# Bryant Development and Review Committee Meeting

**Date:** March 28, 2024 - **Time:** 9:00 AM

### 2. Bryant School Admin Building - 1511 N Reynolds - Site Plan Addition

# **Stormwater Management Report**

C1.1  
3 of 3

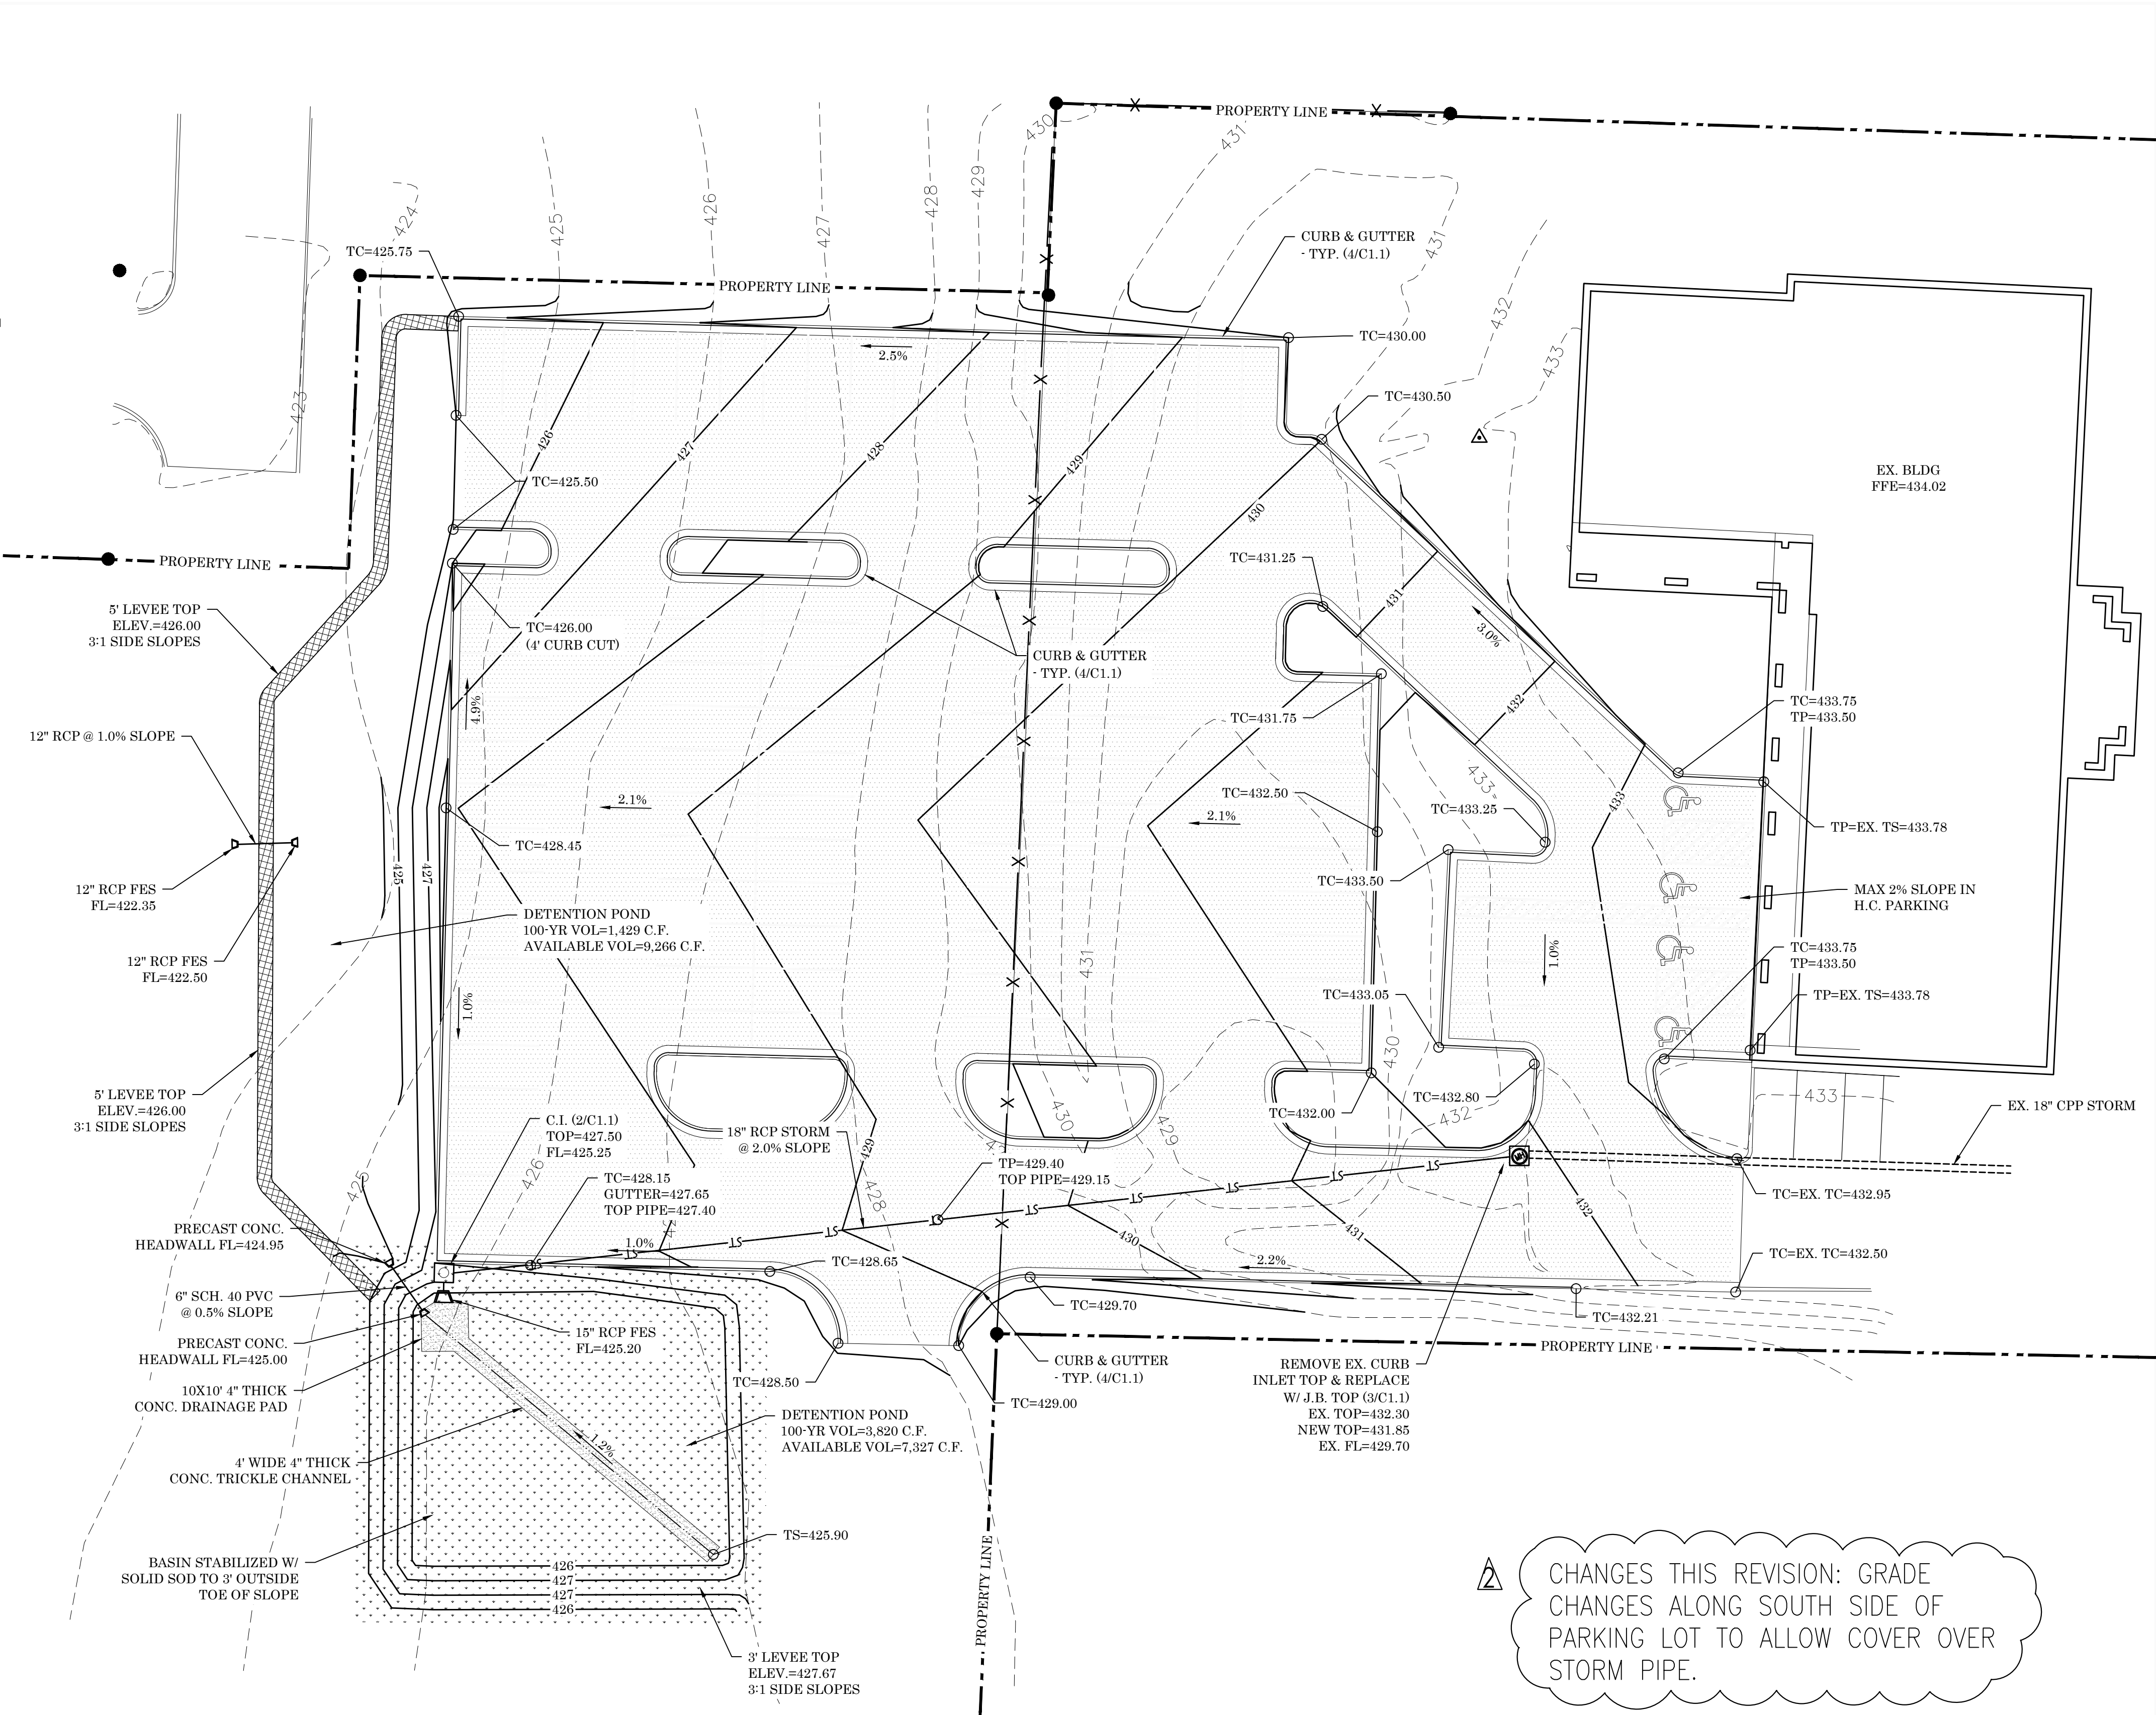
CHANGES THIS REVISION: GRADE CHANGES ALONG SOUTH SIDE OF PARKING LOT TO ALLOW COVER OVER STORM PIPE.

CHANGES THIS REVISION: ADDITIONAL DETENTION POND ADDED ON WEST SIDE OF PARKING LOT.

# Revised Condition MAP

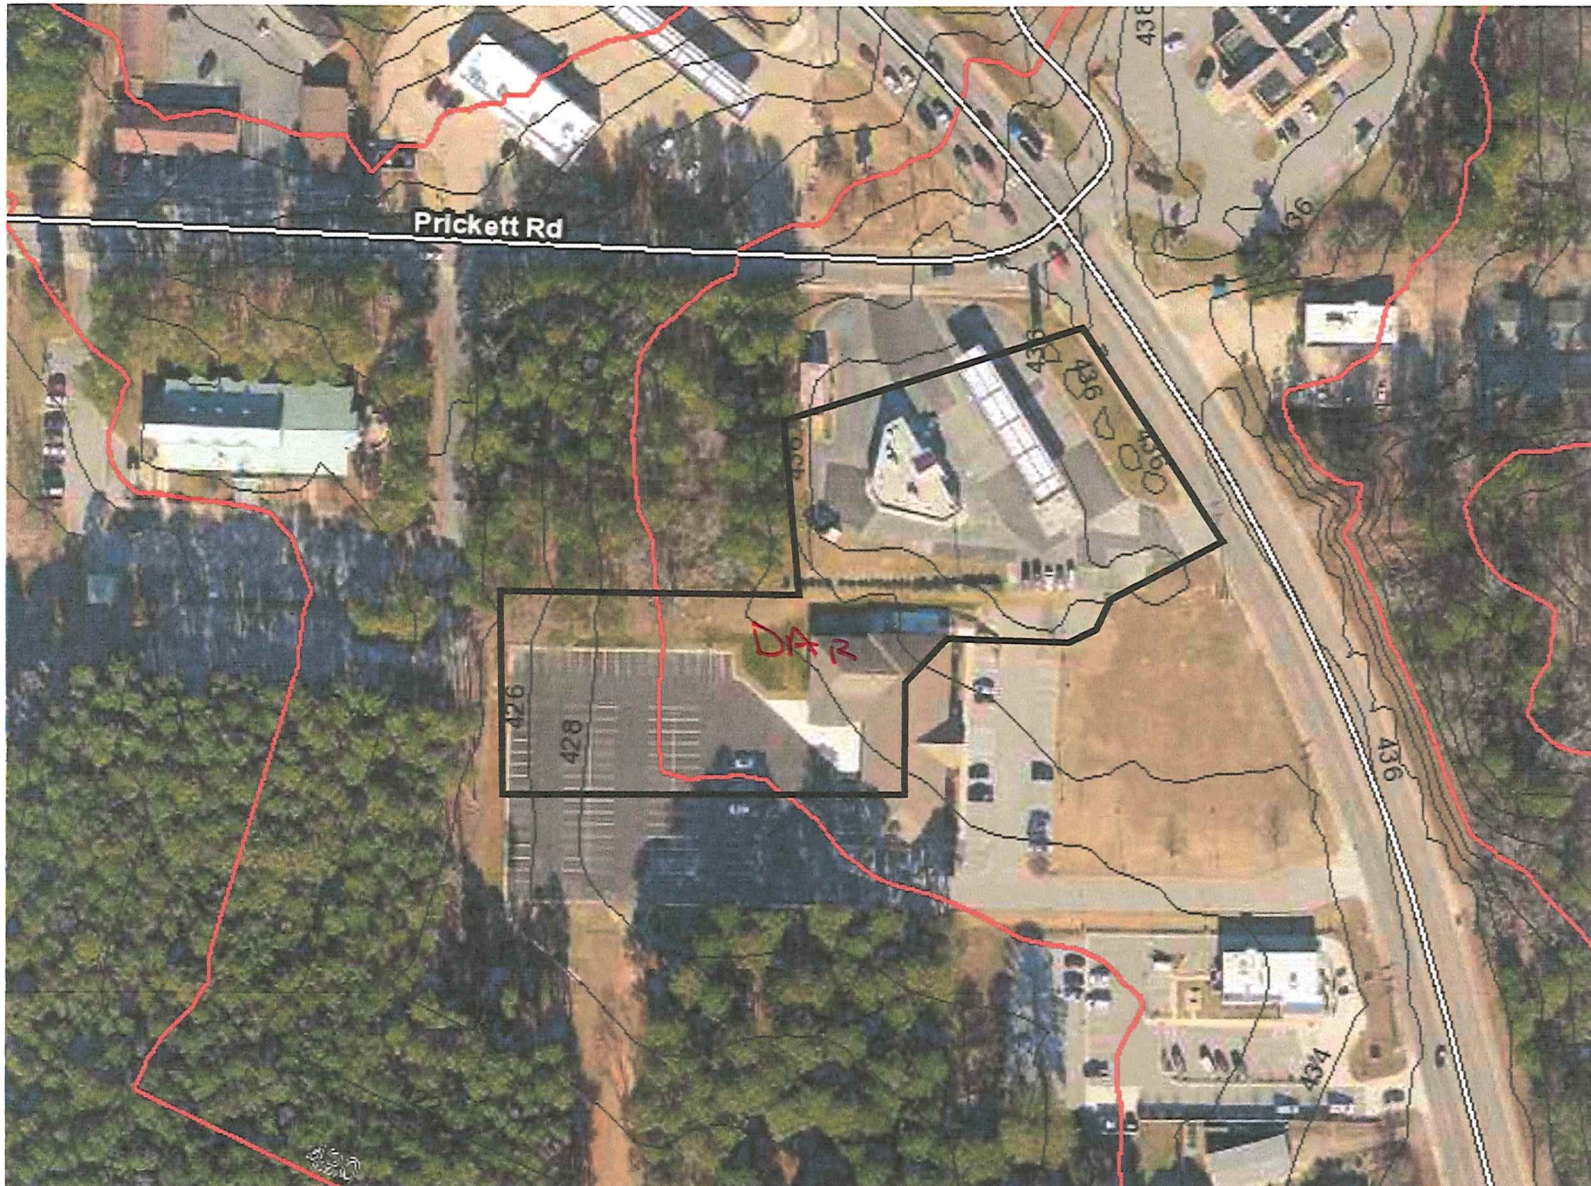
It was brought to our attention that once this project was constructed flooding was occurring to the west behind the Library. We have determined that the existing pond behind the new administration building (previously Summerwood Petroleum) was handling the stormwater not only for this building, but also the gas station to the north. We are proposing to add an additional detention pond that will handle the north portion of our site, as well as the gas station.
